AURIX™ TC4Dx errata sheet

Marking/Step: (E)ES-AB

32-bit single-chip microcontroller
10581AERRA

Figure 1 **System PLL block diagram**

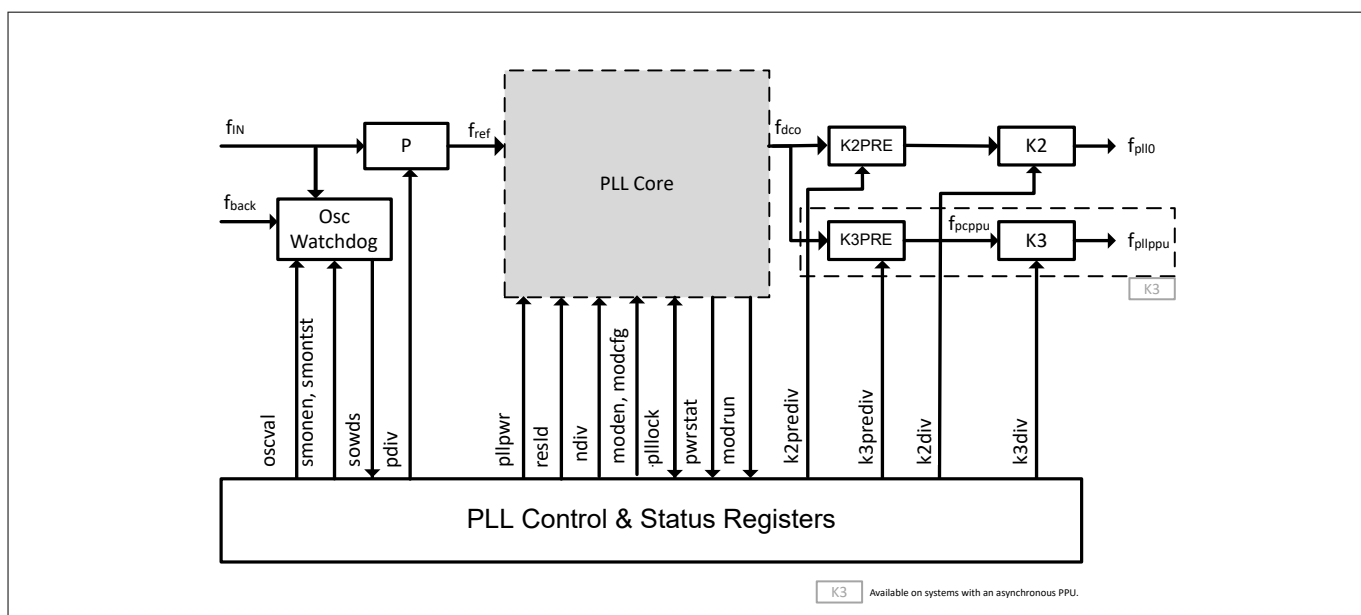
There is an inconsistency between CLOCK_SYSPLLCON1 register description and the Functional description chapter of the SYSPLL. K2PRE is added to the figure with the recommendation to only use the K2PRE = 1.0 pre-divider value. The description is corrected as follows:

Figure 2 CPU block diagram

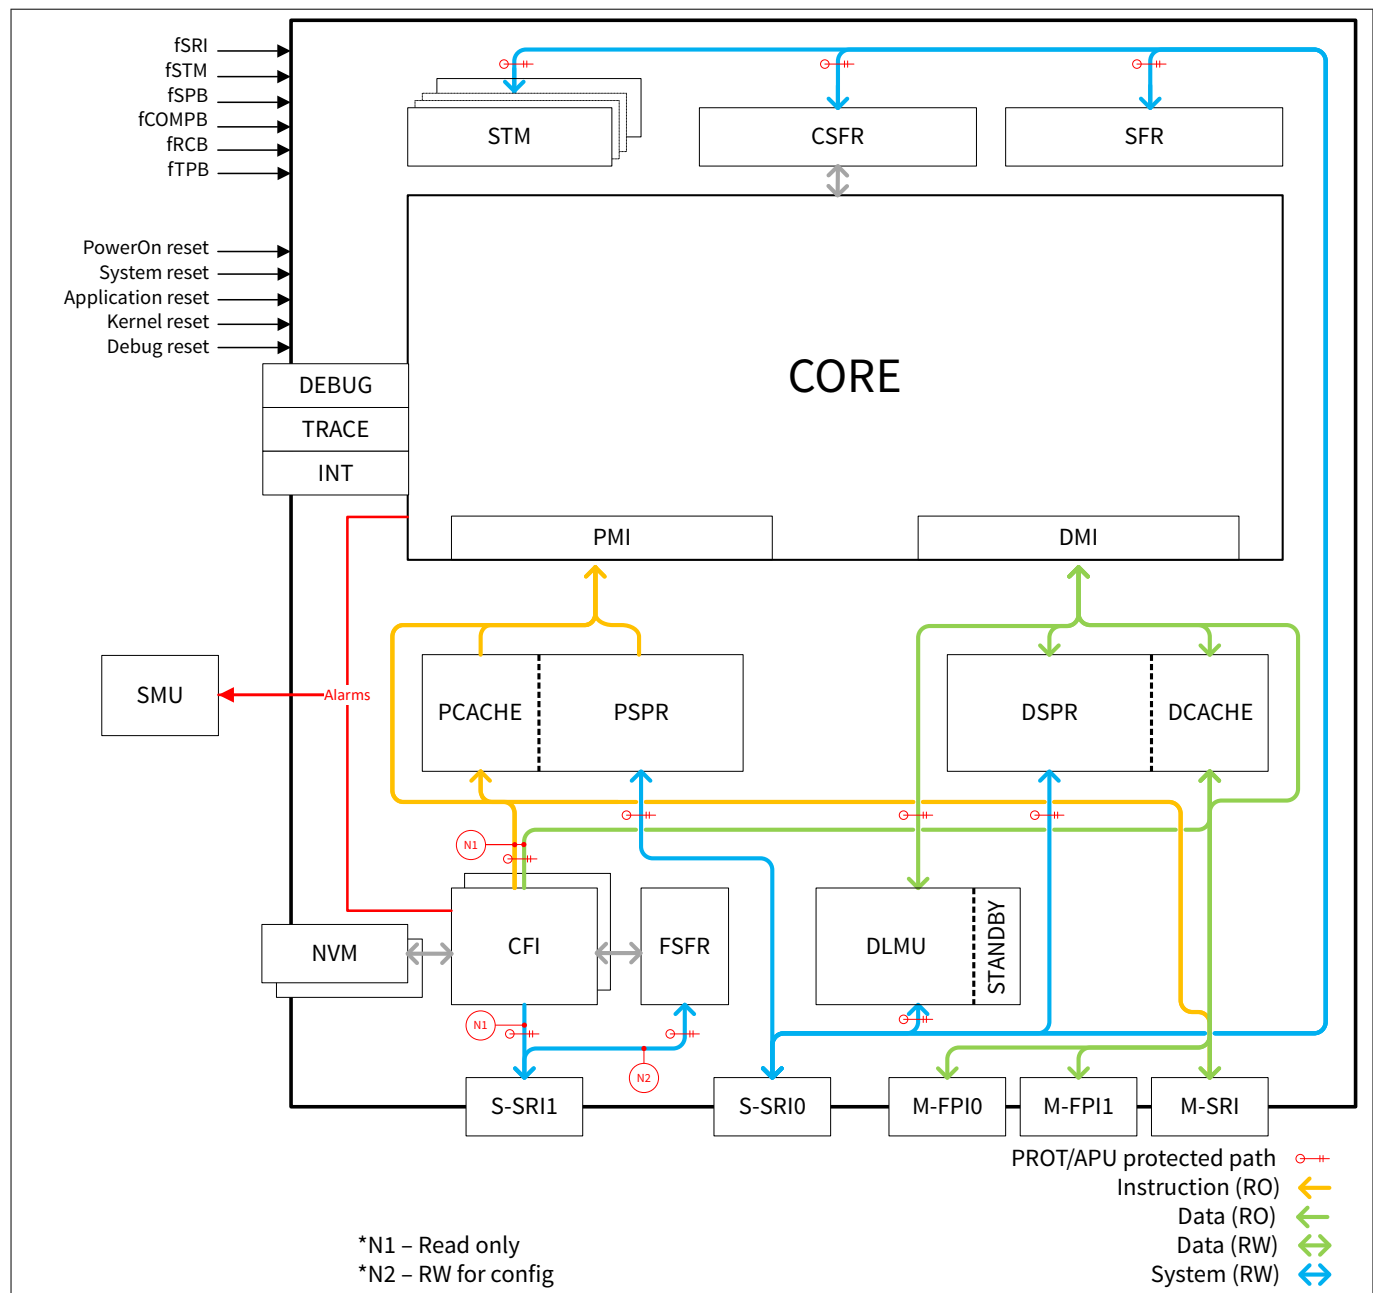
The TC1.8 CPU implements several access protection units (APU), to provide protection against illegal or unintended bus accesses to the local memory system and control registers. The protection does not cover the local accesses to scratchpad RAMs. The CPU block diagram incorrectly shows the following paths as protected, this is incorrect:

The following figure must be used instead:

Figure 4 Message buffer transfer from Message RAM to OBF

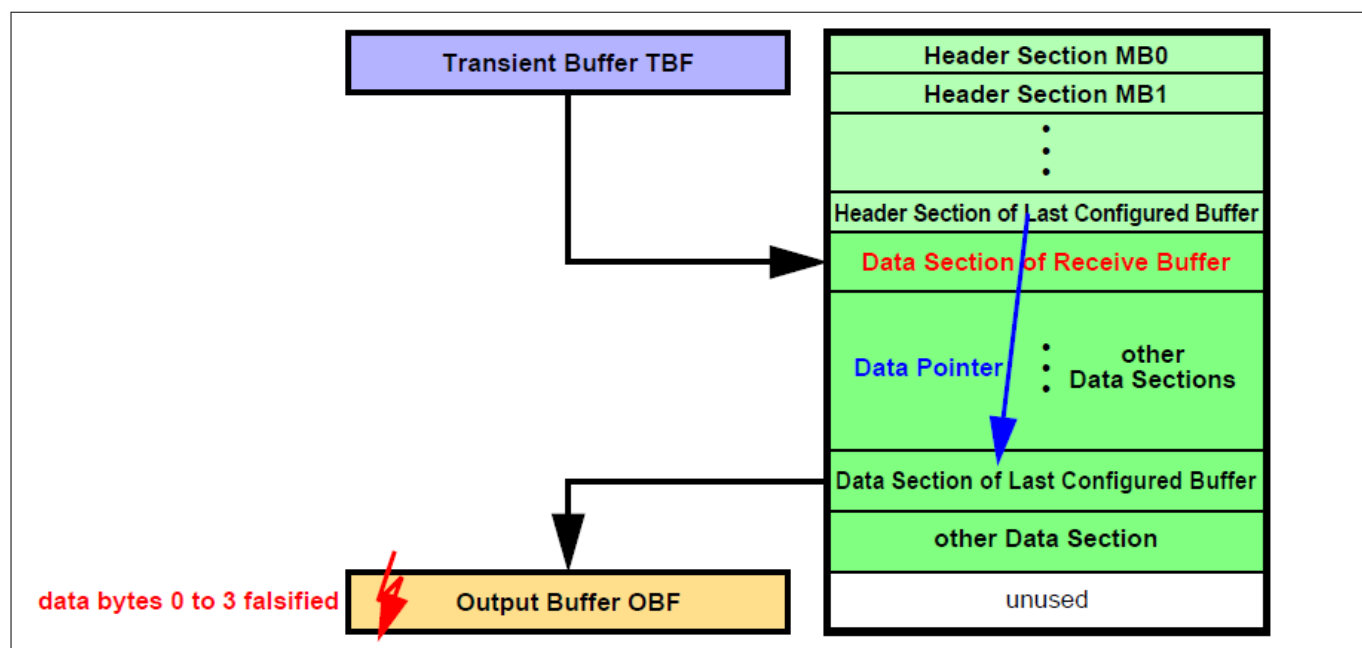
When the message buffer has its payload configured to maximum length (PLC = 127), the OBF word on address 00h (payload data bytes 0 to 3) is overwritten with unexpected data at the end of the transfer.

a) When a message is transferred from the Last Configured Buffer in the Message RAM to the OBF and PLC = 127 it may happen, that at the end of the transfer the OBF word on address 00h (payload data bytes 0 to 3) is overwritten with unexpected data (see [Figure 4](#))

Figure 5 Message buffer transfer from IBF to Message RAM

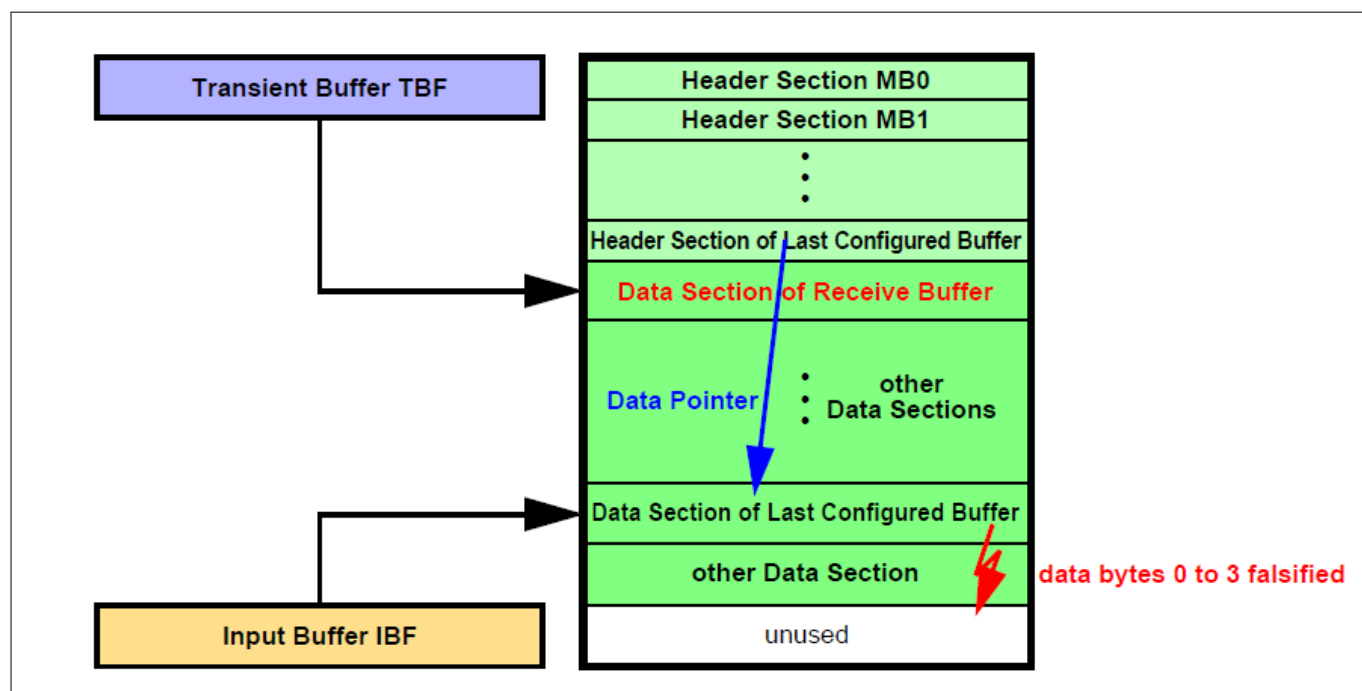
After the Data Section of the selected message buffer in the Message RAM has been written, one additional write access overwrites the following word in the Message RAM which might be the first word of the next Data Section.

b) When a message is transferred from IBF to the Last Configured Buffer in the Message RAM, it may happen, that at the end of the transfer of the Data Section one additional write access overwrites the following word, which may be the first word of another message's Data Section in the Message RAM (see [Figure 5](#))

Figure 6 Message RAM configurations

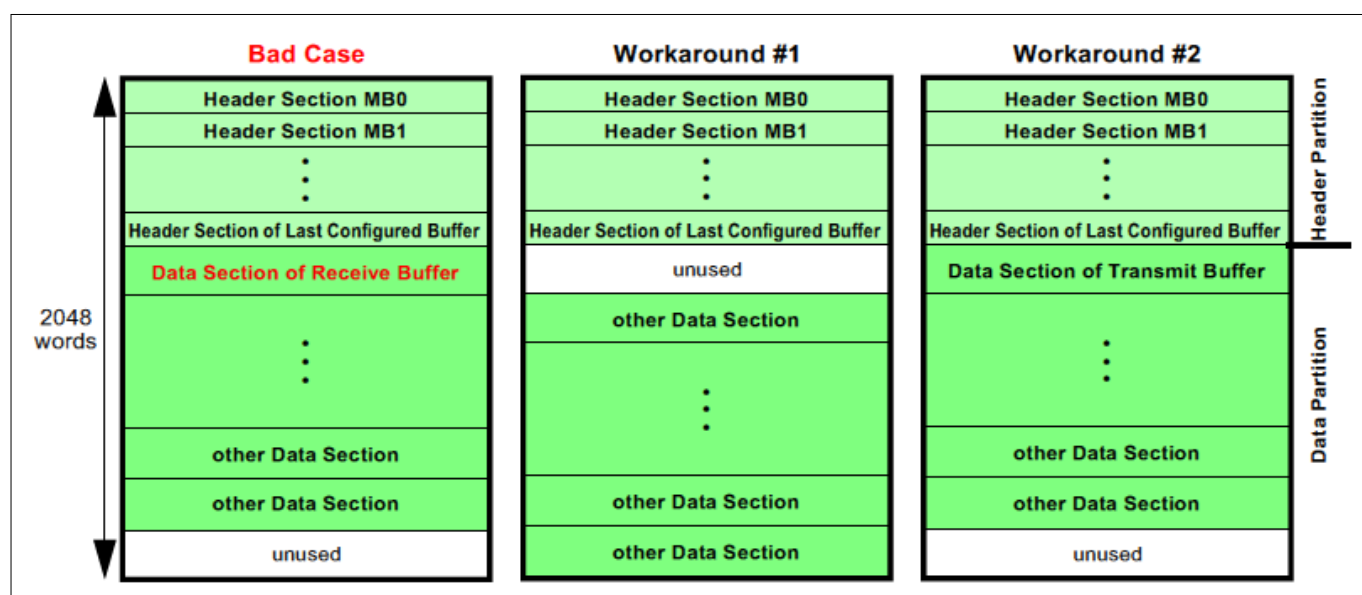
The erratum is limited to the case when (see Figure 6 "Bad Case"):

Ensure that the Data Section directly following the Header Partition is assigned to a transmit buffer.

Figure 7 Timing of LVDS TX interface command sending in relation to IRQ.IFCFS

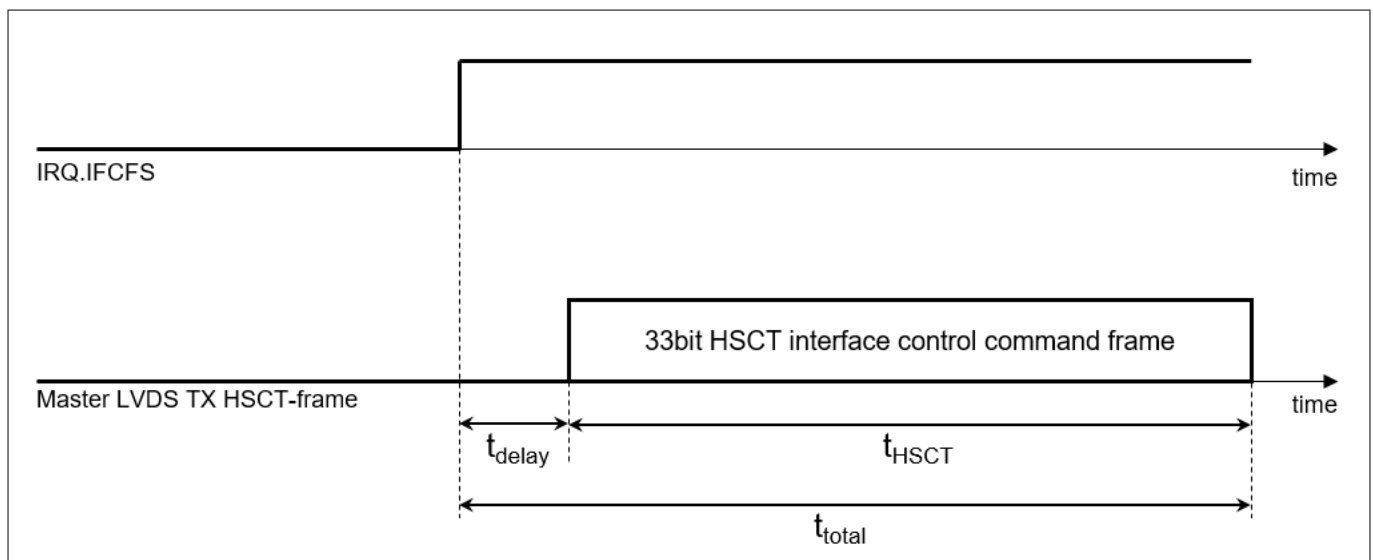
the user might falsely assume that also the actual sending on the LVDS TX port has already occurred once the IRQ.IFCFS flag is set, which is not true.

Instead the timing shown in the following figure applies.
